PLANNING COMMISSION MEETING
ISD #15 District Office Building 4115 Ambassador Blvd.
Wednesday, September 21, 2022 at 7:00 PM

TO: St. Francis Planning Commission
FROM: Beth Richmond, Planner
SUBJECT: Rivers Edge 7th Addition
DATE: 9-14-2022 for 9-21-2022 meeting
APPLICANT: St. Francis Land Development, LLC (Dale Willenbring)
LOCATION: 23925 St Francis Blvd NW
COMP PLAN: LDR, Urban Reserve, Park/Open Space
ZONING: Rivers Edge PUD, Urban Reserve, Rum River Management District (rural)

**ENGINEERING REVIEW
for City of St. Francis
by
Hakanson Anderson**

**Proposed
Project: Rivers Edge 7th Addition**

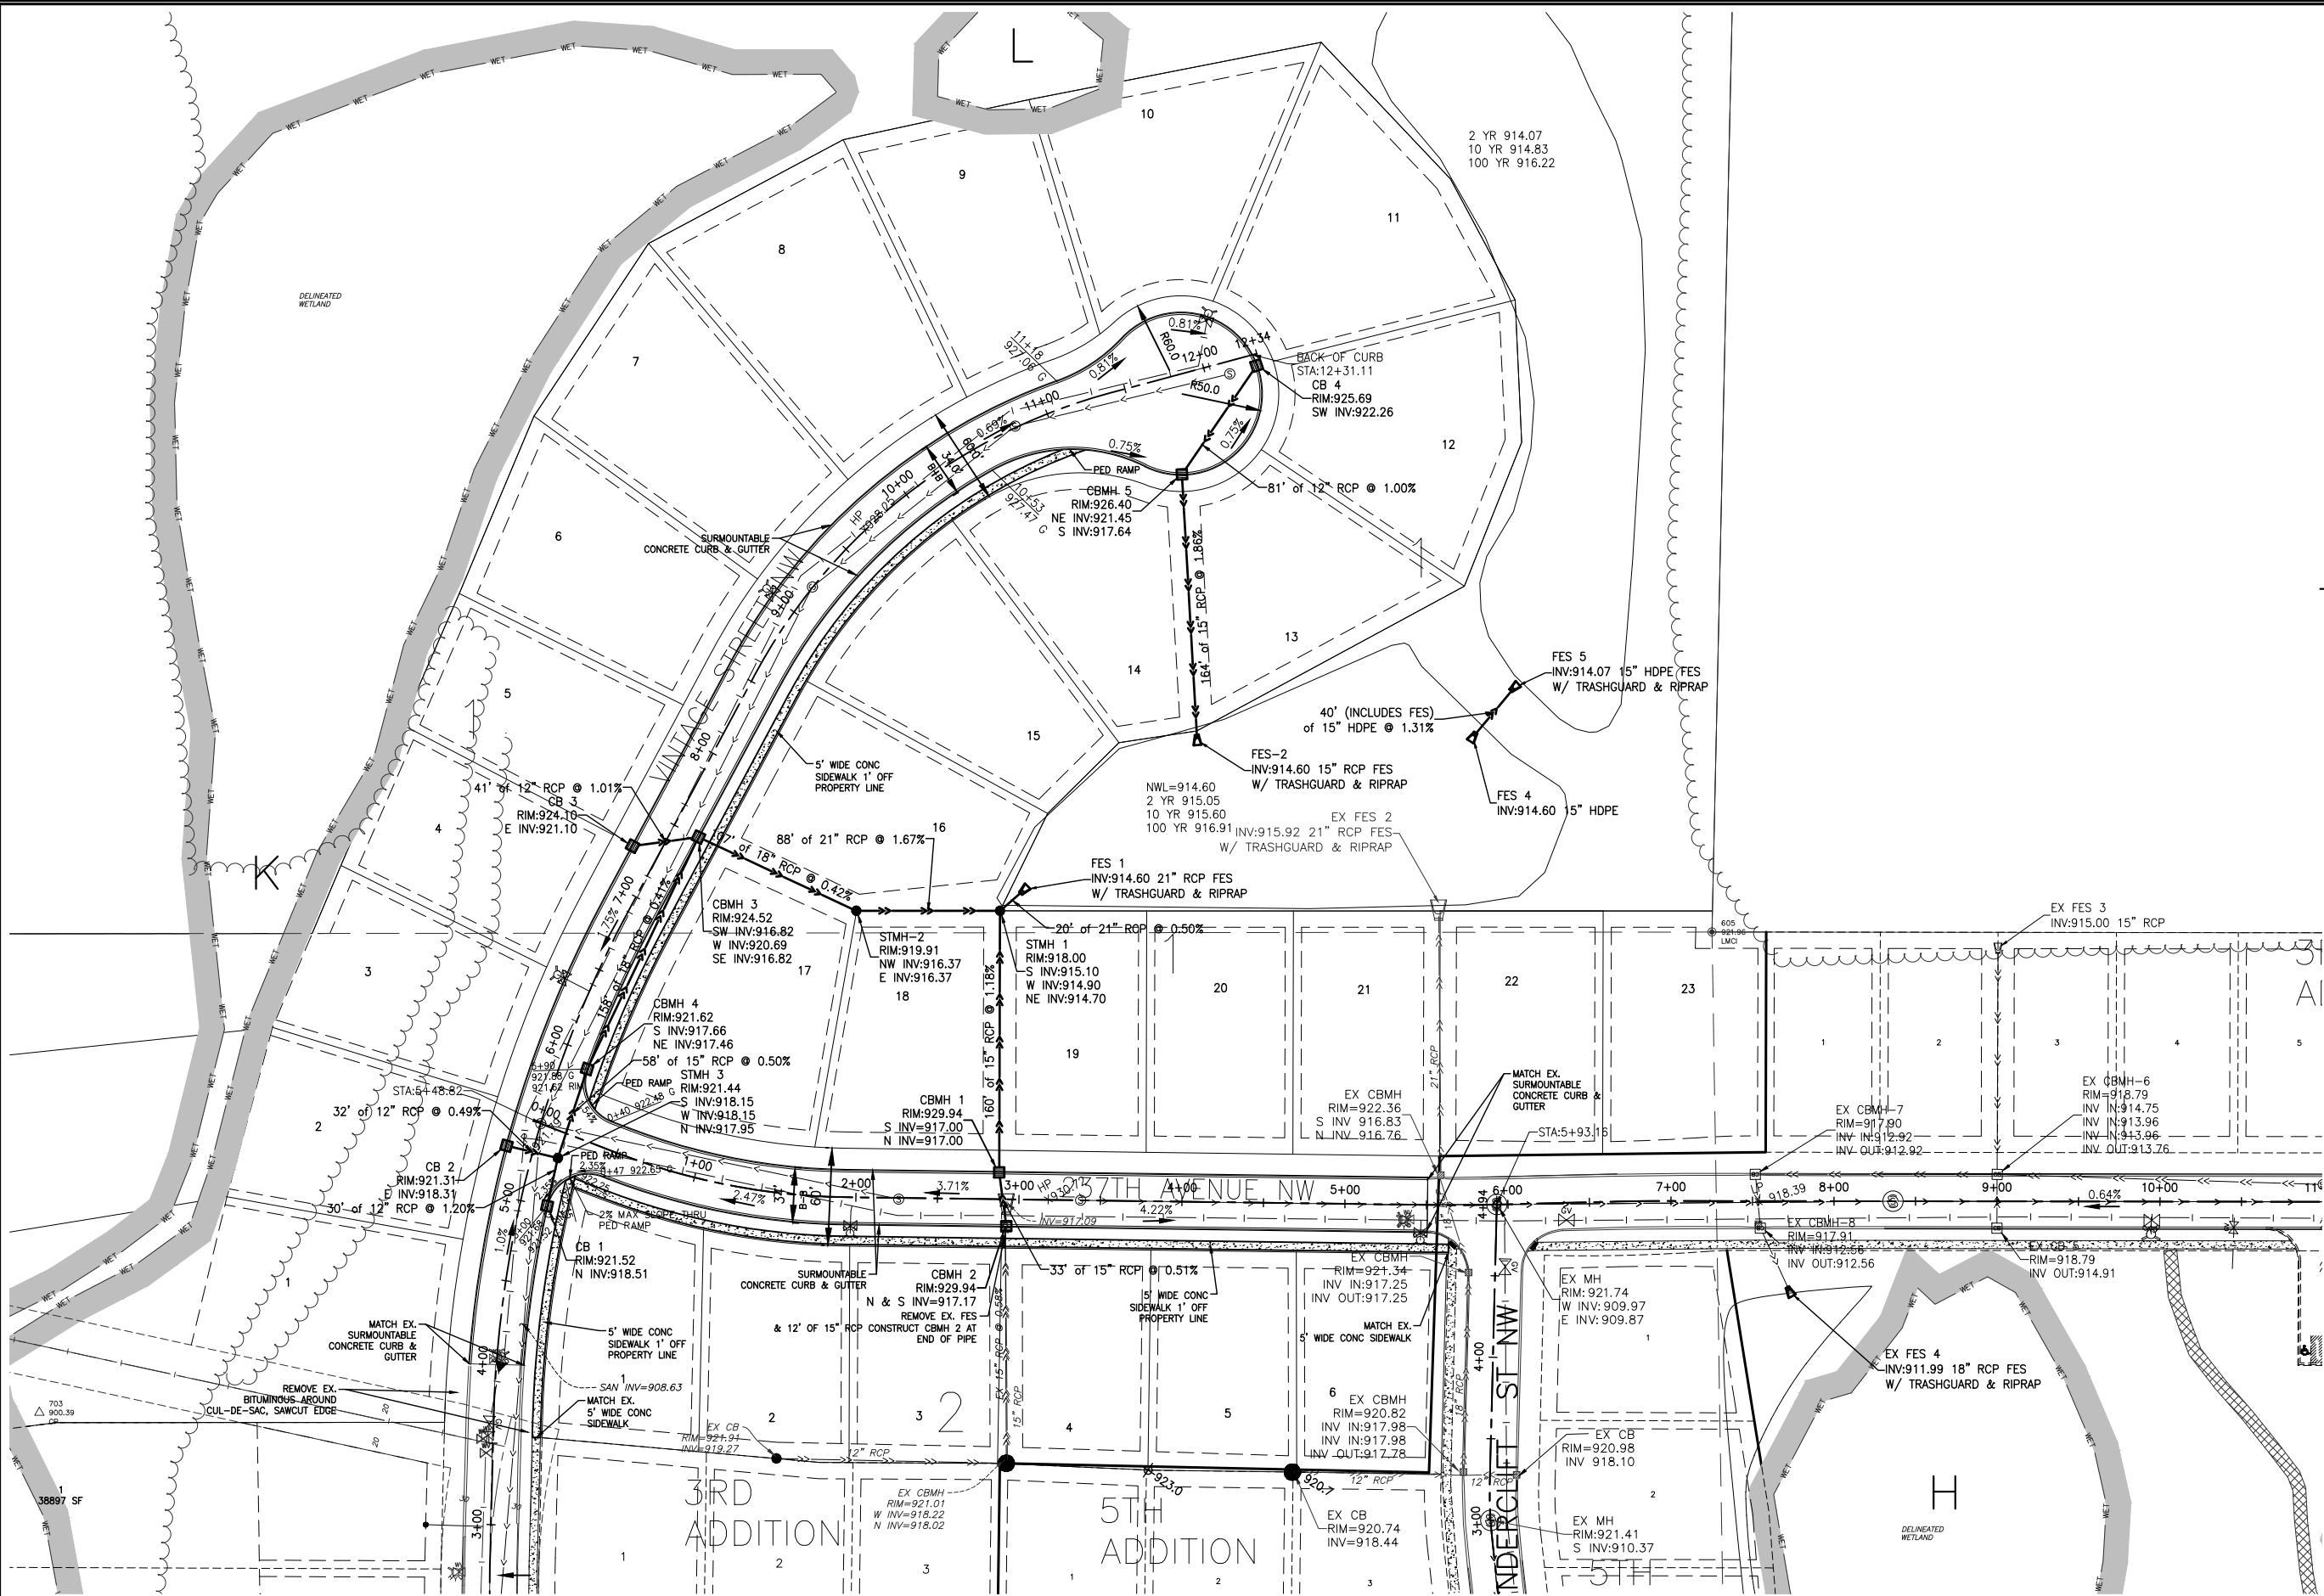
1. The proposed development will receive its access via local City streets and will connect to Vintage Street NW on the west side of the development and 237th Avenue NW on the east side. The street connection/network as proposed is acceptable.
2. The crest vertical curve located at station 3+25 of 237th Avenue NW does not meet the design speed of the road. The vertical curve shall be revised such that it meets a 30 mph design speed.

1. The stormwater is proposed to be managed by the construction of two stormwater basins. One stormwater basin is proposed to be a wet sedimentation basin, and the second is proposed to be an infiltration basin.
2. Storm sewer sizing calculations shall be provided with the final plans.
3. A skimmer structure is required for the Pond 1P outlet.

PRELIMINARY GRADING PLAN

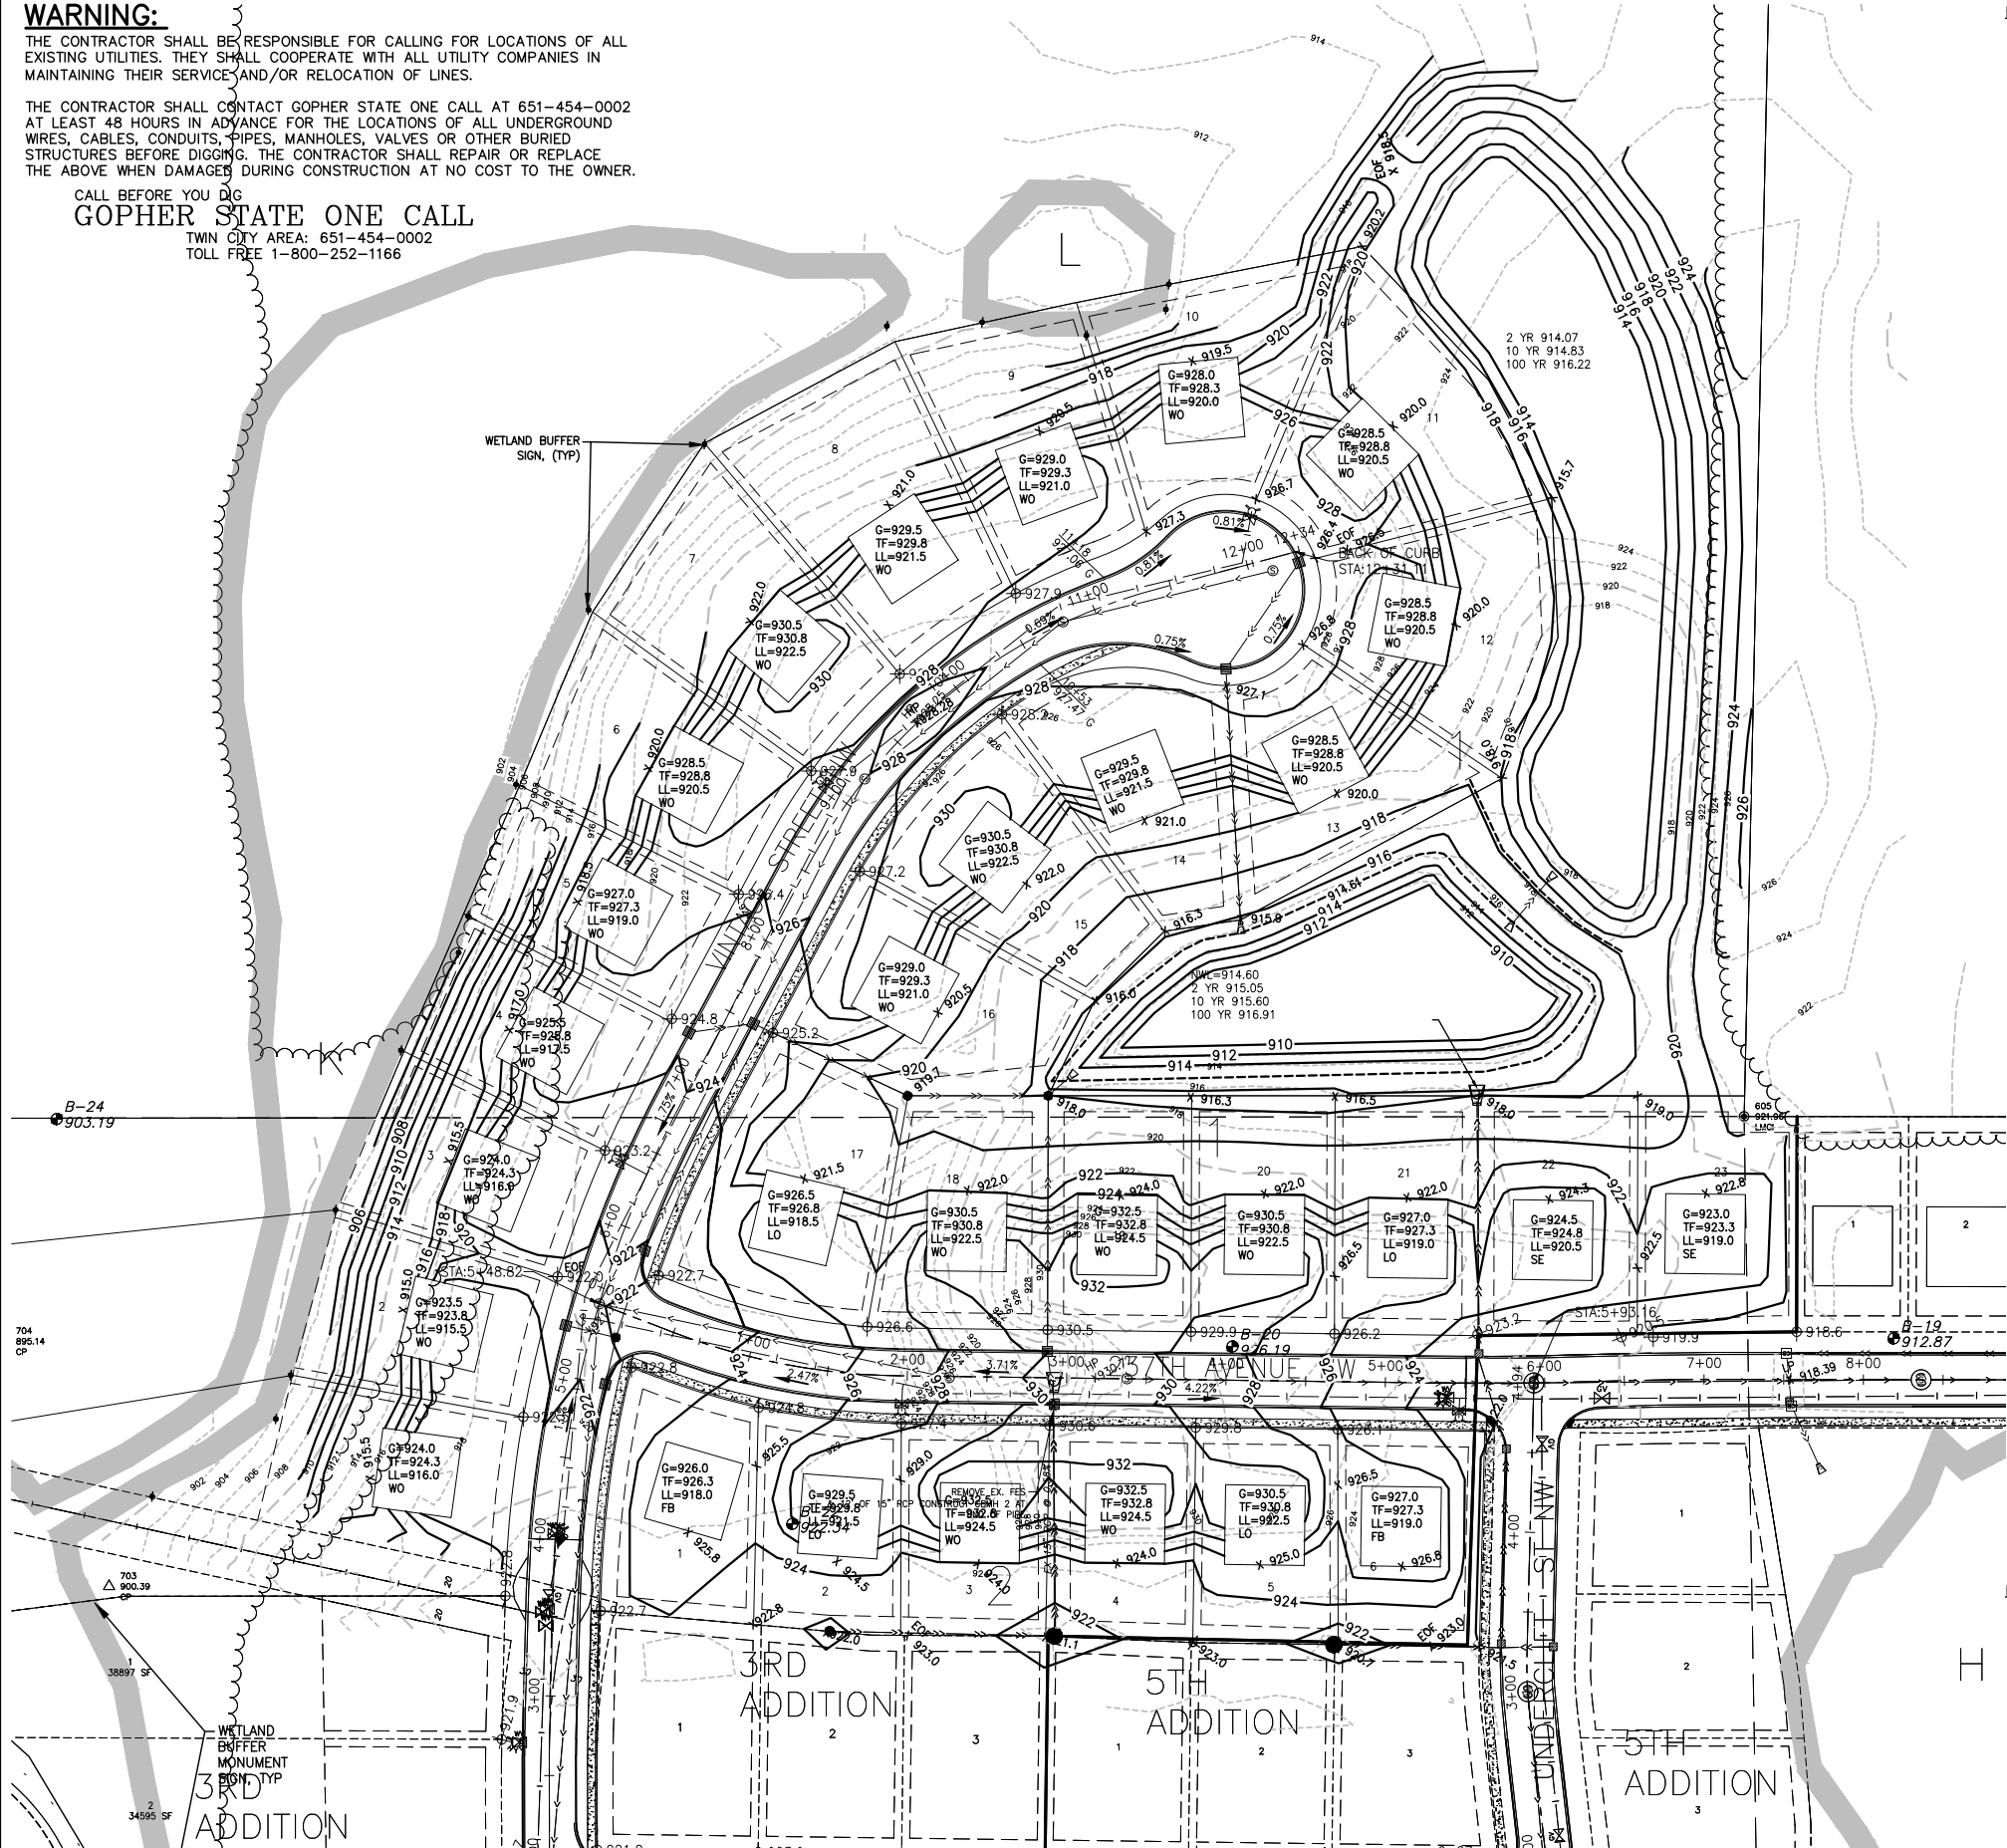
In addition, we strongly recommend the applicant prepare a tree protection plan. Substantial tree clearing is likely for block 2, lots 1-5, based on the grading plan. We recommend that a plan be developed for this area with custom lot grading so that individual mature trees may be identified for protection.

PRELIMINARY GRADING PLAN

1. The Normal Water Level (NWL) and High Water Level (HWL) of all wetlands shall be labeled on the final plans.
2. The 100 year flood elevation of the Rum River shall be labeled on the Final Grading Plan.
3. Riprap overflow spillways shall be provided for the stormwater basins.
4. A detail for the infiltration basin construction shall be provided with the final plans, including a seed mixture that is appropriate for the basin as per MN Stormwater Manual guidance.
5. The final plans shall depict stormwater basin access routes. Access routes shall be at least 10 feet wide, contained within an easement, and have gradients that do not exceed 8%.
